MECHANICAL RELEASE MODULE

P/N: 18001

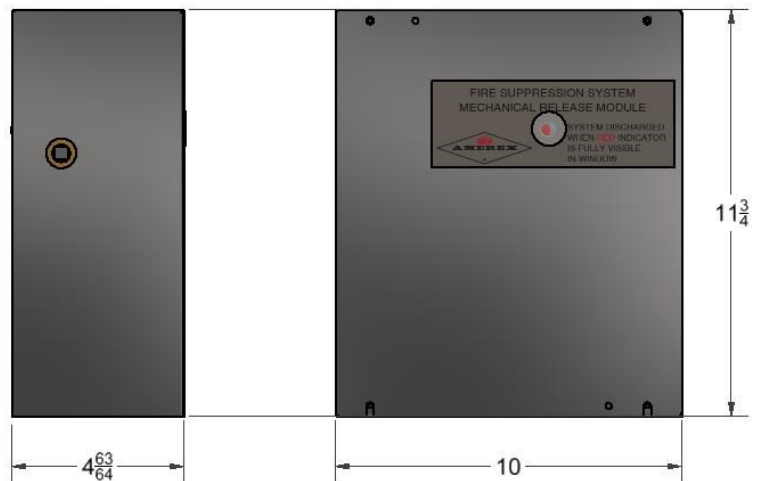
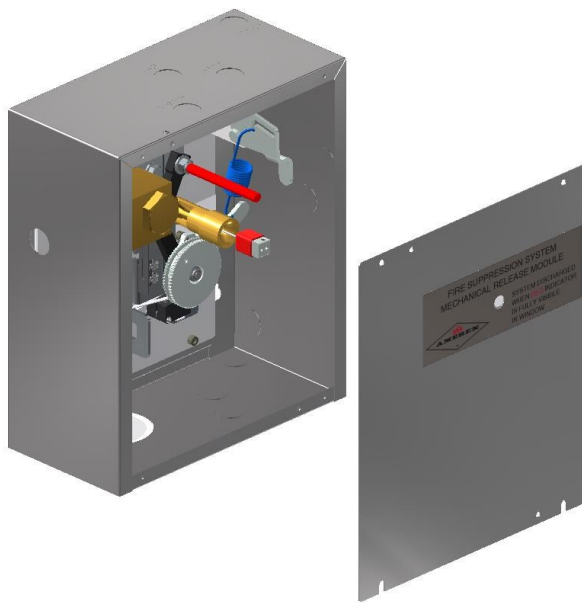
The new MRM combines the same features and functionality as the original MRM along with increased detection capabilities and far simpler means of setting the detection cable tension. The slide plate and collapsible column are now Teflon coated. The MRM is available in the above configurations, now preinstalled in its own enclosure.

Setting the detection cable tension does not require the use of any tools (once the cable is locked down into the large, knurled ratchet wheel). A large lever to the right of the ratchet wheel is used to increase the cable tension. Alignment of the bottom edge of the lever with markings on a label indicates when the proper tension has been achieved. Lowering cable tension to change out detection links is now also much simpler.
